Surface Water Quantity Models Progress Meeting Notes

December 9, 2015 – Teleconference

South Carolina Surface Water Quantity Modeling Project

Lake Greenwood during 2002 Drought

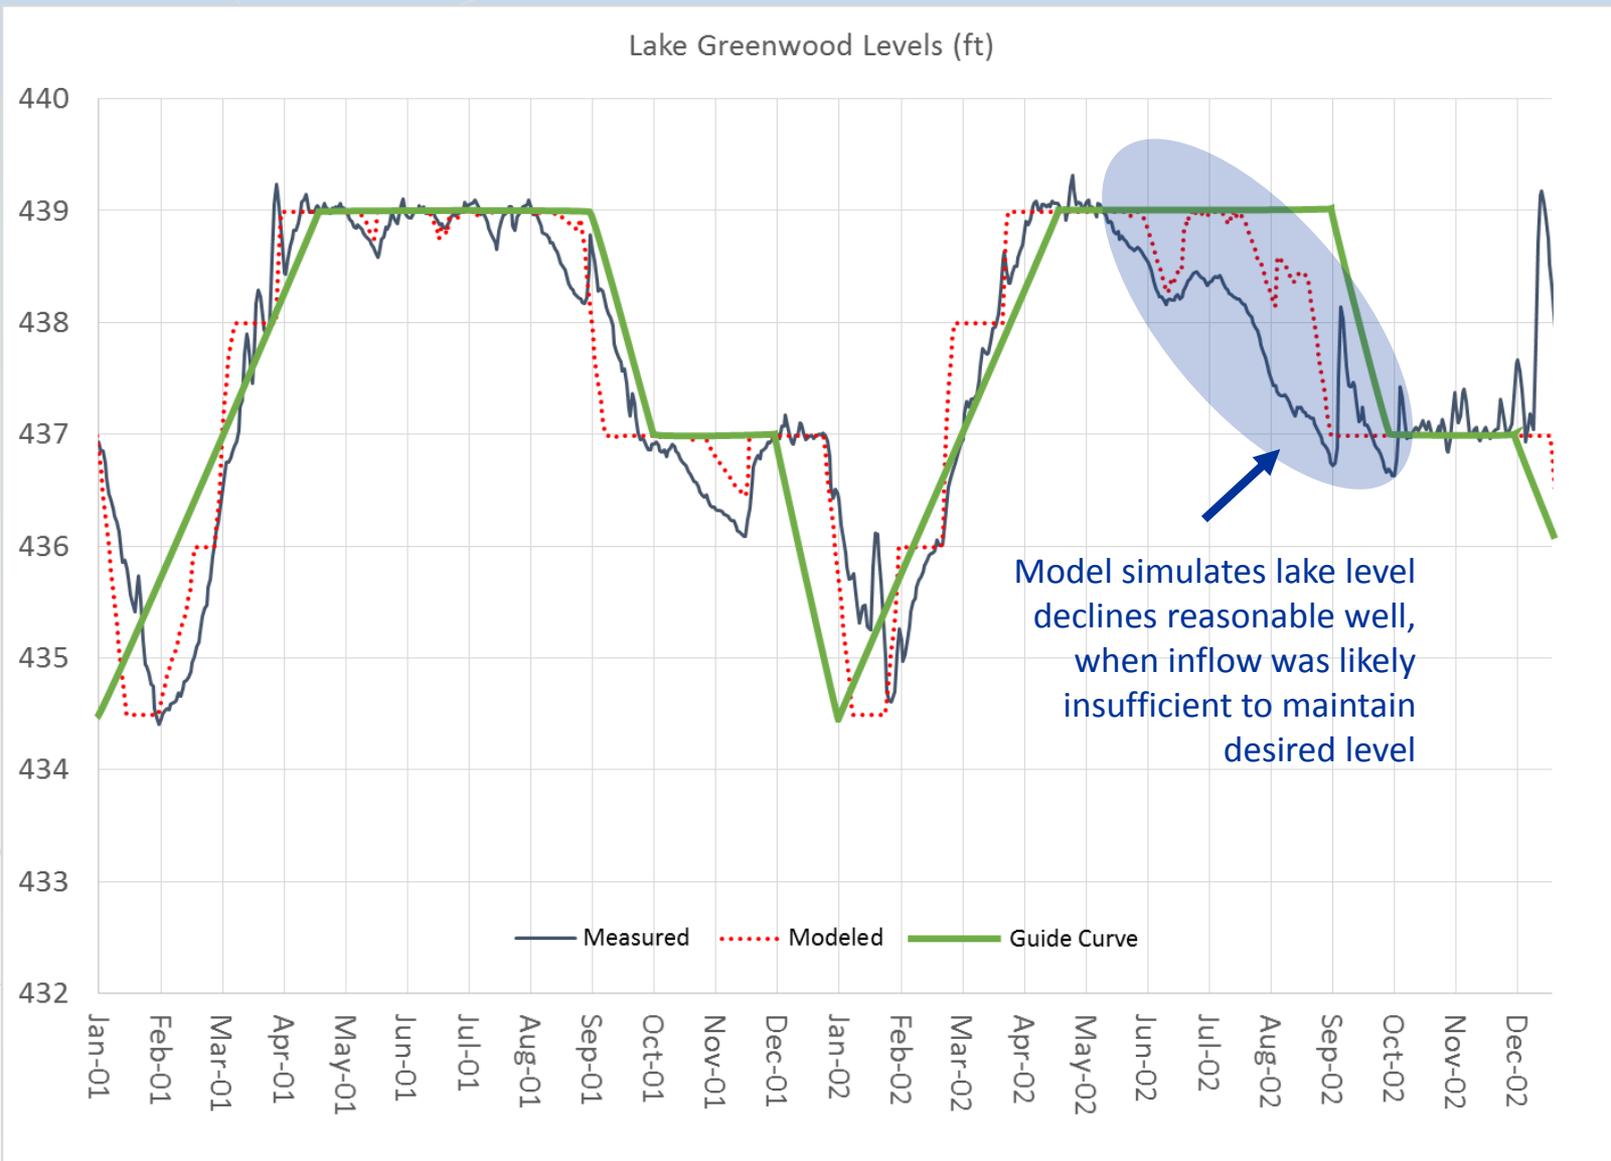
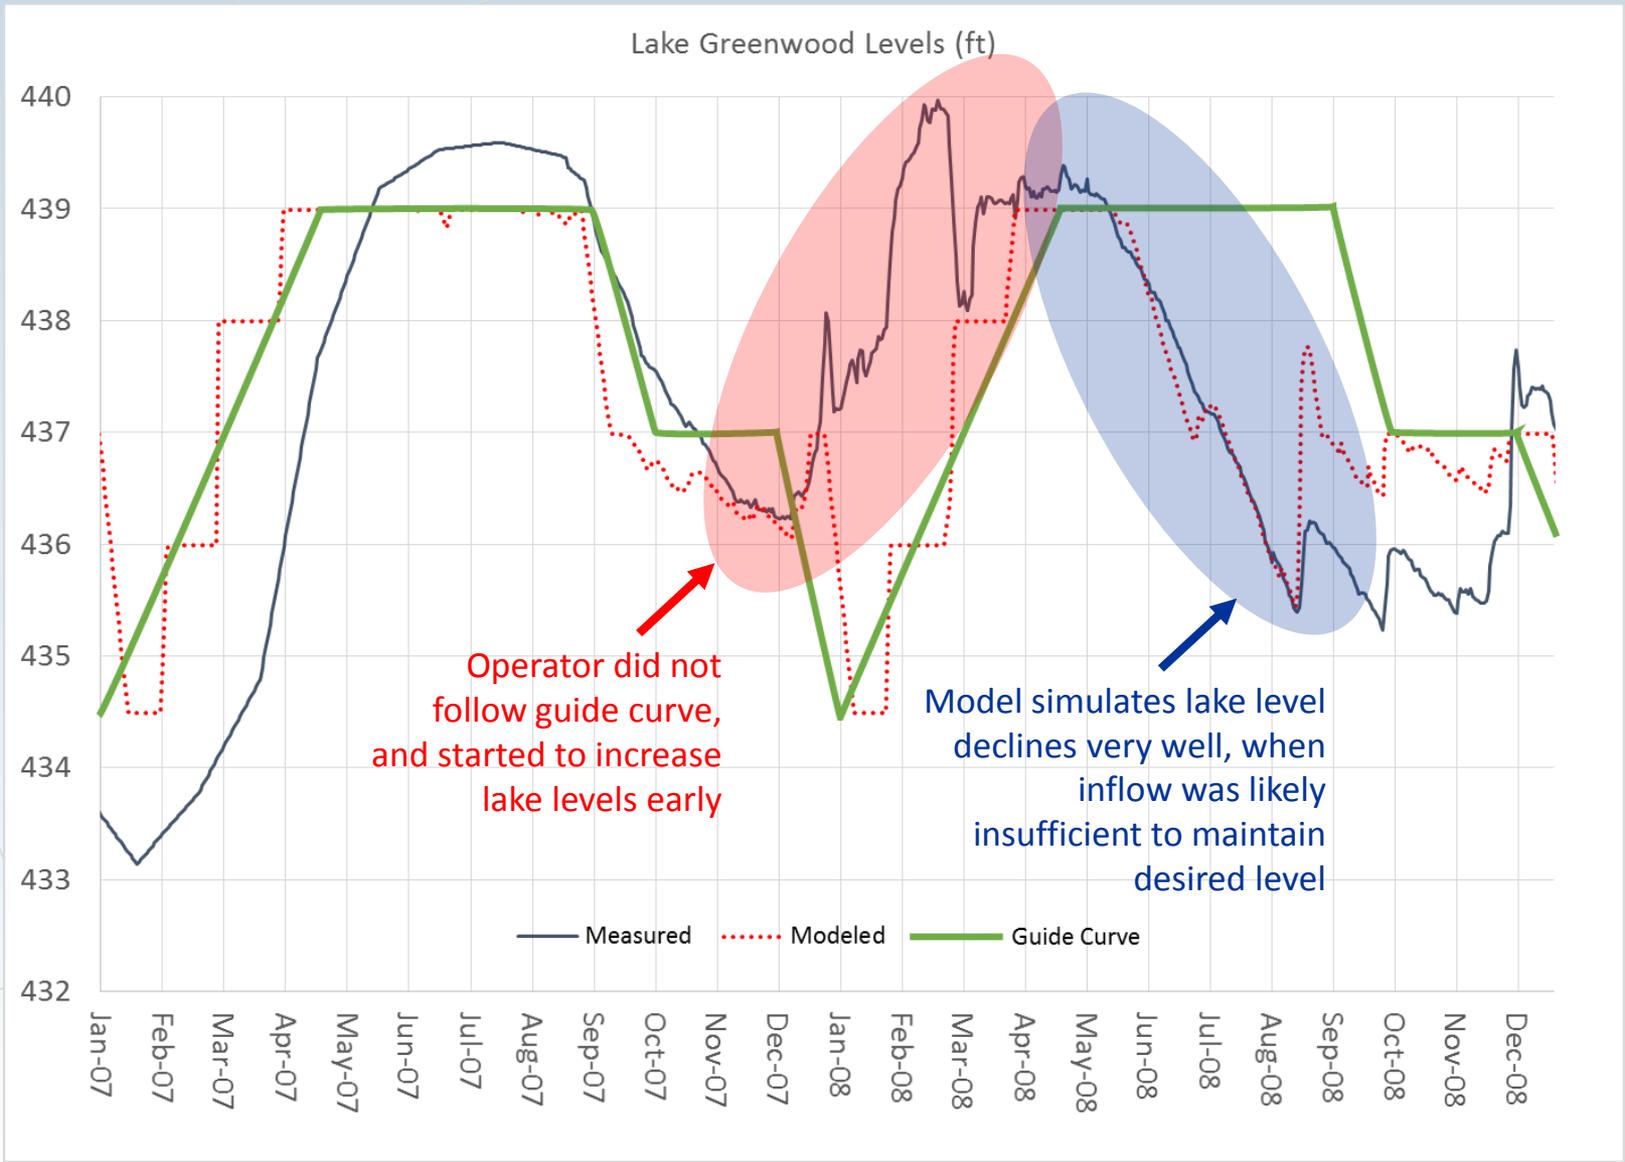
- Ed Bruce noted that one thing water allocation models don't account for, which may be important in times of drought, is the potential loss to groundwater (i.e., seepage from the lake). This loss may explain why model lake level declines may not be as severe as actual declines, in some instances.

- It was noted that SWAM accounts for evaporation from the lake (based on model estimates – not pan data).
 - Ed Bruce noted that the tailwater USGS gage from Lake Greenwood could be compared to modeled outflow as another evaluation of model performance during the droughts.

- Comment #5 (11/23/2015)
 - “...detailed review of a drought year(s) for Lake Greenwood and Lake Murray to test whether the model was reproducing any resulting declines in lake elevations. “

- b. Response to Comments (slides)
 - In response to one of DNR's requests, John Boyer presented a comparison modeled vs. actual lake levels in Lake Greenwood, during the 2002 and 2007-8 droughts. In the 2002 drought, the graph demonstrates that the model simulates the lake level declines reasonably well, when inflow was likely insufficient to maintain the desired level. In 2008, the modeled levels closely follow the actual summertime declines, which varied greatly from the guide curve.
